**IN THE MATTER** of Plan Change 5 – Peacocke to the  
Operative Hamilton City District Plan

**STATEMENT OF  
TROY DION RADOVANCICH**

**18 September 2022**

**Figure 2: PC5 Zoning of 241 Dixon Road (Brown = High Density Overlay Area, Green = Natural Open Space Zone, Hatch = Waikato River Gully Hazard Area WRGHA). The brown area corresponds with the area of 241 Dixon Road that is the subject of my submission.**

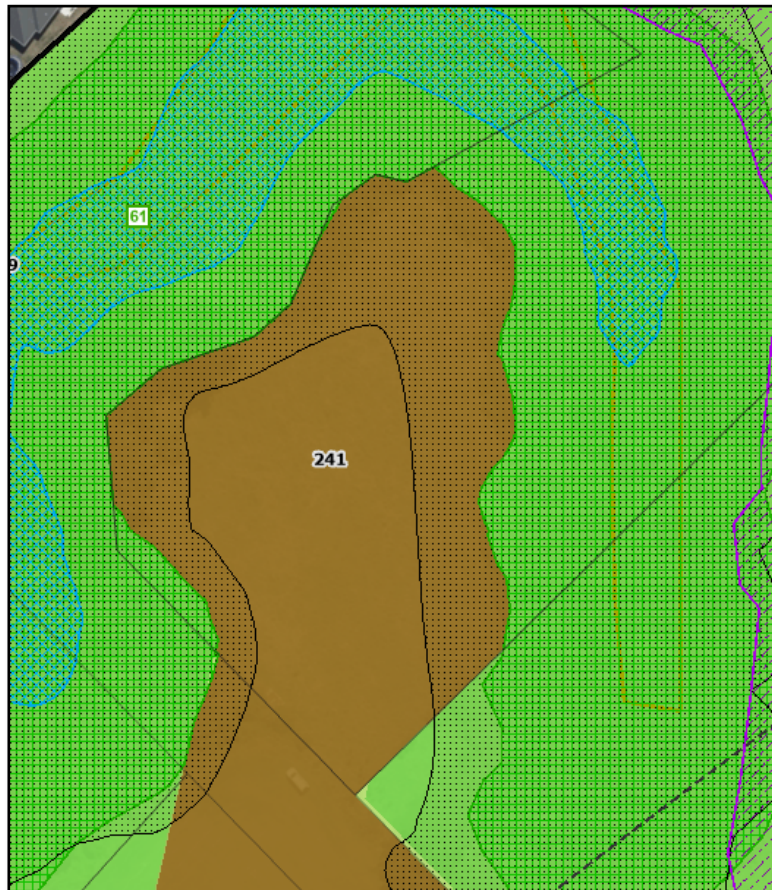
- 16. Should our property be developed in the future, the part that is proposed Natural Open Space Zone would be vested in HCC as Local Purpose Reserve. The part that is proposed Medium Density Residential Zone with High Density Overlay could be developed into residential allotments.
- 17. As can be seen from Figure 2, a significant portion of the land zoned

Medium Density Residential Zone with High Density Overlay is subject to the WRGHA (the hatch).

18. It is the position of the boundary of the WRGHA that we object to.
19. The second portion of my statement relates to the protection of future road access to the property. At present vehicle access is only possible from Hall Road. The property fronts an unformed part of Hall Road. See **Figure 3** below. Despite being addressed as a property on Dixon Road, vehicle access is not possible from Dixon Road as there is an impassable gully separating the property from Dixon Road.

Figure 4: WRGHA and 6m setback over 241 Dixon Road.

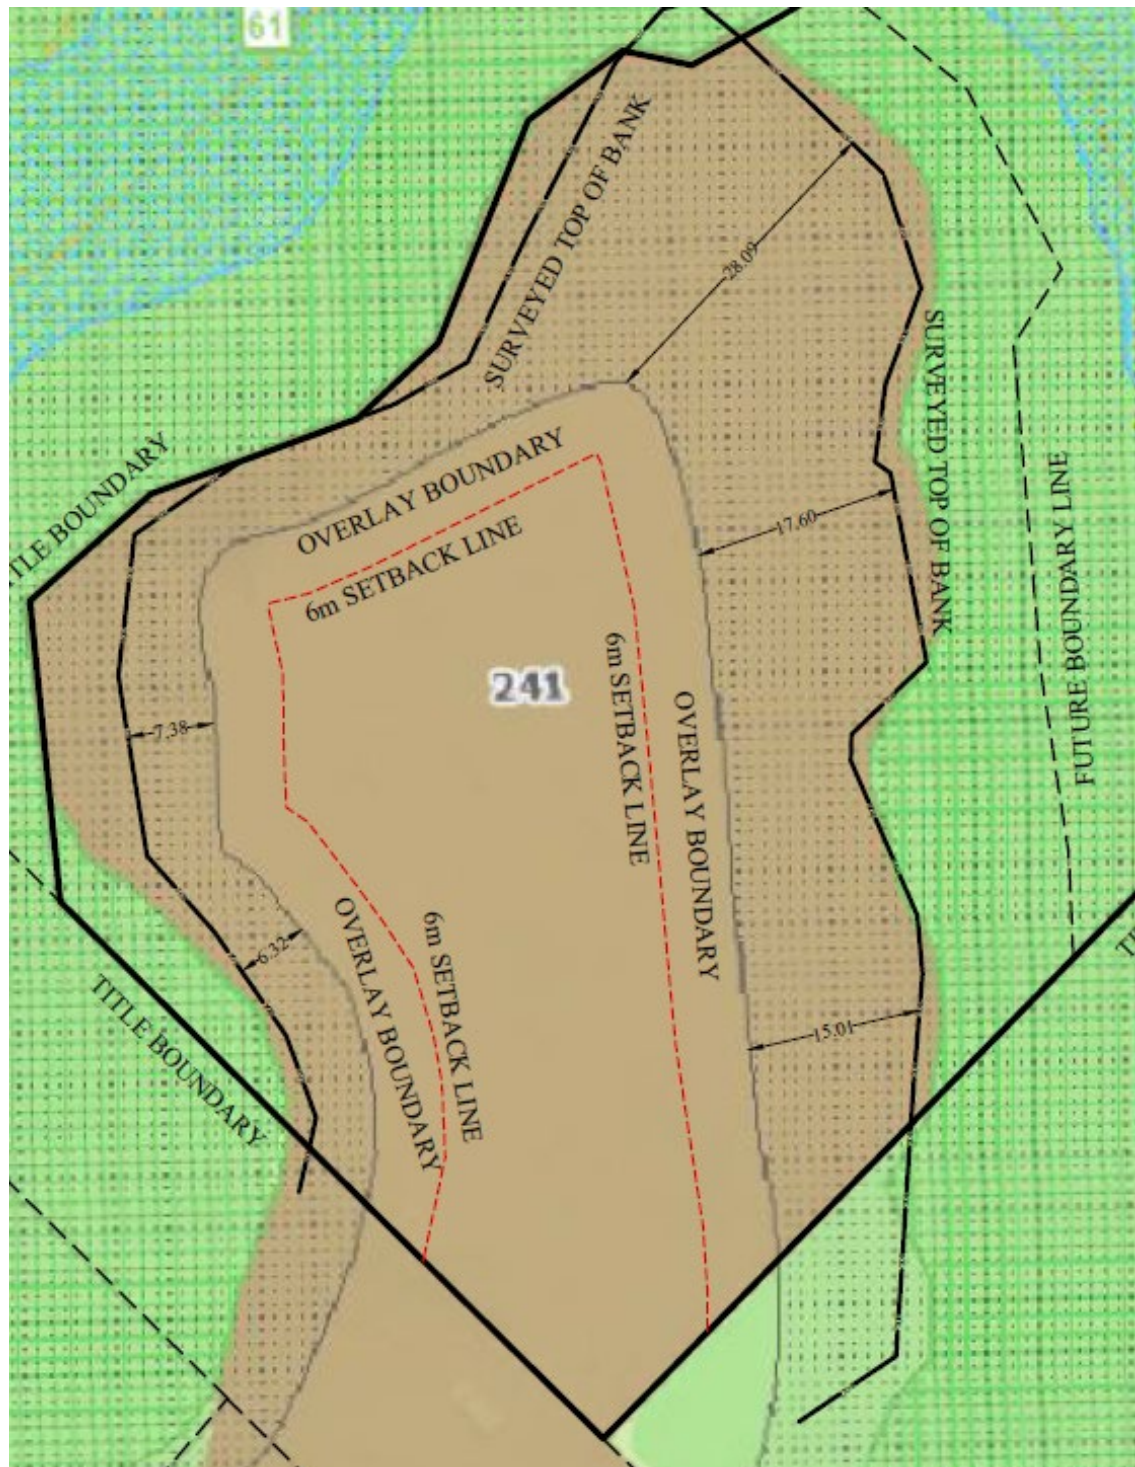
28. As it is currently drawn, the WRGHA extends beyond the top of bank by approximately 6m to 28m. Then the 6m setback is applied. This creates an area of 12m to 34m of flat land, from the top of the gully bank within which no development can occur. This reduces the developable area of 241 Dixon Road from 3943m<sup>2</sup> to 1835m<sup>2</sup> (54% reduction). **Figure 4** shows the spatial extent of the WRGHA and the 6m setback line.

39. The AECOM maps are not sufficiently accurate and do not include sufficient detail for me to verify if the boundary of WRGHA in the Planning Maps aligns with the Primary setback line identified by AECOM. But I consider there is a risk that AECOM have adopted the existing 6m setback from the top of the gully bank as the Primary Setback Line which HCC has then adopted as the boundary of the WRGHA to which an additional 6m building setback applies. Thus, where there was originally a 6m setback there is now a 12m setback. This is illustrated by the western boundary of our property where there is now a 12m-13m setback proposed – see **Figure 4** above.

58. It is my opinion that the WRGHA ought to be set to the top of the gully bank. A 6m setback from the top of bank will serve to mitigate possible land stability risks and effects. This is because, Council has existing mechanisms that it regularly uses (s 106 RMA and the Information Requirements under the District Plan) to request information about land stability, erosion, earthquake or another natural hazards that are relevant to the site.

- (a) the boundary of the WRGHA should be set to the top of the gully bank, with a requirement that each site that adjoins a WRGHA provide a site-specific geotechnical assessment that establishes the setback line in relation to the property in question to accompany a development proposal.
- (b) If Council choose to retain the WRGHA boundary as currently drawn, then provision ought to be included that allows the setback from that boundary to be varied by means of a site-specific geotechnical assessment that establishes the setback line in relation to the property in question.
